Work Order ID December-21-11 9:54			*777	793*							Page 1
Item ID: D407- Revision ID:	-667-205TRN		Accept	*N900	040	100) * s	Setup		*N	S1*
Item Name: Crosst	ube Turning Detail								Stop	*N	S2*
Start Date: 21/12	/2011 Start Qty: 1.00	*1*		Cust Item I	D:						
Required Date: 06/01/	/2012 Req'd Qty: 1.00	*1*		Customer:							
Approvals: Proc	ess Plan: _M.し.ブ	Date: \\\\\\\\	么 Tooling: _	Da	ate:		F		Start	*N	R1*
QC:		Date:	SPC (Y/N):	Da	ate:				Stop	*N	R2*
Sequence ID/ Work Center ID	Operation Description		Set Up/ Run Hours	Tool ID	Tool #	Plan Code	Accept Qty	Reje Qty		Reject Number	Insp. Stamp
Draw Nbr	Revision Nbr					· - ·					
D407-667-245	Rev F										
100			0.00				1		· · · · · ·		
100	MORI SEIKI CNC LA	ATHE LARGE							T)		
Mori Seiki	Memo		0.00						7		
Mori Seiki CNC Lathe Large	1-Fill tub	e with sand & install plug	s DT8531 on both ends as pe	r Folio FA248				(•		
	2-Turn fir	rst side as per Folio FA24	8			/	1. 111	/	١.	1.1

DART AEROSPACE LTD	Work Order:	77793
Description: Crosstube Assembly	Part Number:	D407-667-245
Inspection Dwg: D407-667-245 Rev: F		Page 1 of 1

DRAWING NO. D407-667-245	TITLE CROSSTUBE	E ASSY (407 HIGH	REV. F	DART AERO	SPACE LTD ING ORDER	,	o. 67-245

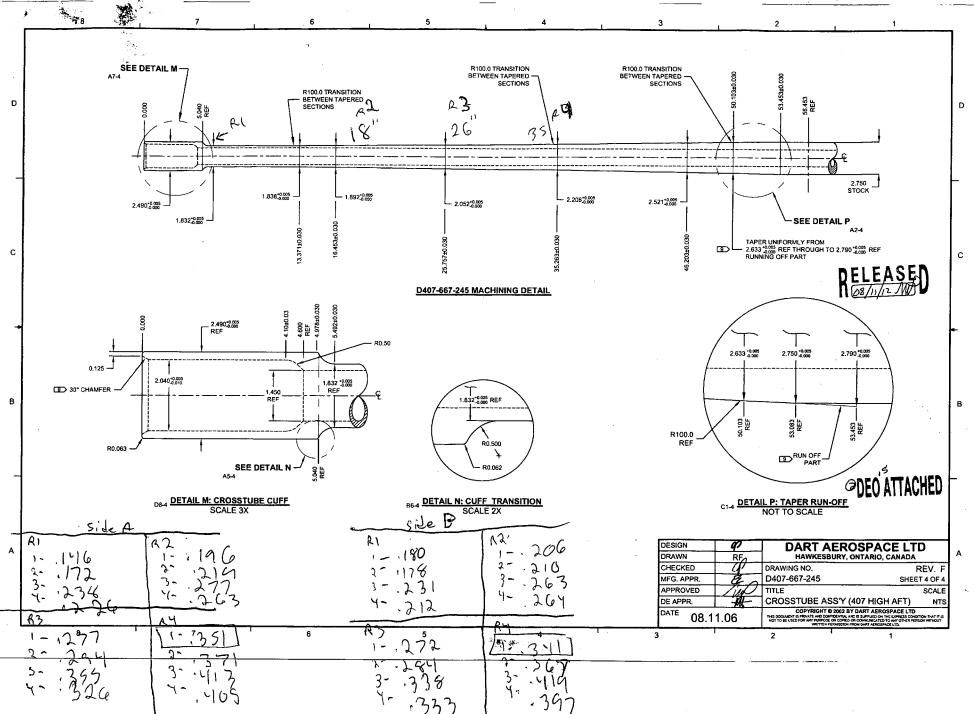
PURPOSE:

REMOVED ABRASION STRIP IN FAVOR OF A THIN LAYER OF PROSEAL 890.

PARTS LIST IS AMENDED AS FOLLOWS:

NOTES 2 AND 15, SHEET 1 ARE AMENDED AS FOLLOWS:

IS:

Item	Qty -245	Part Number	Description
3	0	D2856-400-773	ABRASION STRIP

<u> 18:</u>

- 2) FINISH: CHEMICAL CONVERSION COAT PER DART QSI 005 4.1 PRIME INSIDE AND OUTSIDE PER DART QSI 005 4.2 MASK UNDERSIDE OF CROSSTUBE AS SHOWN (HATCHED AREA) AND PAINT OUTSIDE PER DART QSI 005 4.2 REMOVE MASKING AND APPLY CLEAR COAT
- 15) APPLY A THIN COAT OF PROSEAL 890 ON INSIDE CONCAVE SURFACE OF D3190-1 CHAFING SHIELDS AND LET CURE PER MANUFACTURER'S INSTRUCTIONS. INSTALL PROSEALED D3190-1 CHAFING SHIELDS ONTO CROSSTUBE BY APPLYING A THIN COAT OF PROSEAL 890 ONTO CROSSTUBE. BE SURE TO ELIMINATE ANY AIR GAPS.

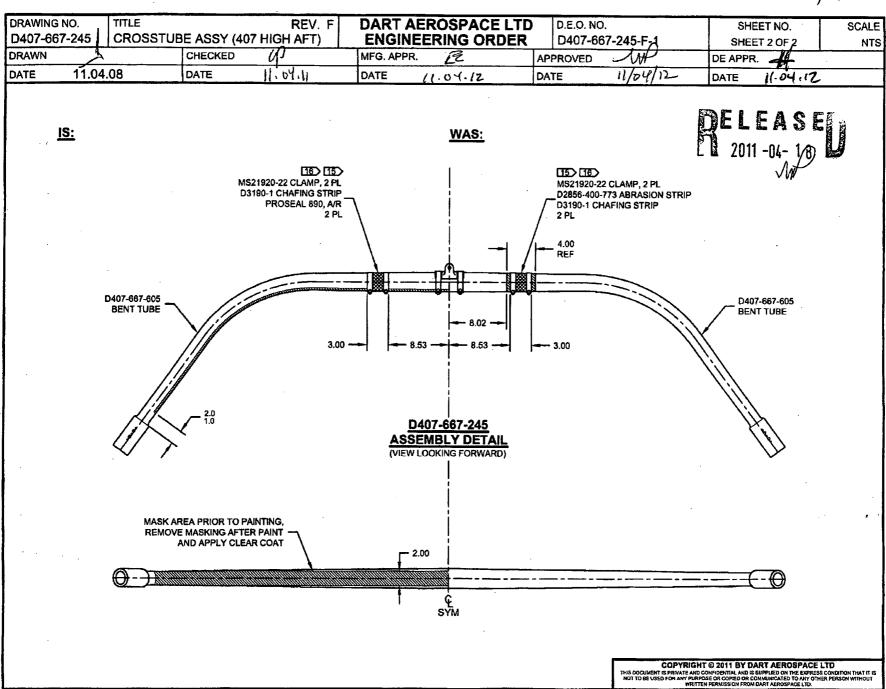
PURPOSE:

REPLACE MAGNOBOND WITH 3M DP460 SCOTCH-WELD EPOXY ADHESIVE

NOTE 12 & 17, SHEET 1 IS AMENDED AS FOLLOWS:

IS:

Item	Qty -245	Part Number	Description
12	A/R	SCOTCH-WELD DP460	EPOXY ADHESIVE, 3M SCOTCH-WELD

IS:

- 12) INSTALL D2894-1 CENTER SUPPORT USING A 0.04" TO 0.07" THICK LAYER OF SCOTCH-WELD DP460 PER QSI 015. LET CURE FOR 24 HOURS AFTER INSTALLATION AND PRIOR TO PACKAGING.
- 15) TORQUE CLAMPS 80 TO 100 IN-LB. ENSURE AT LEAST 1.5 THREADS SHOWING IN SAFETY AND THAT NUT HAS NOT BOTTOMED-OUT AFTER TORQUING. PRIOR TO PACKAGING, RE-CHECK TORQUE ON CLAMPS AFTER ADHESIVE HAS CURED FOR 24 HOURS.
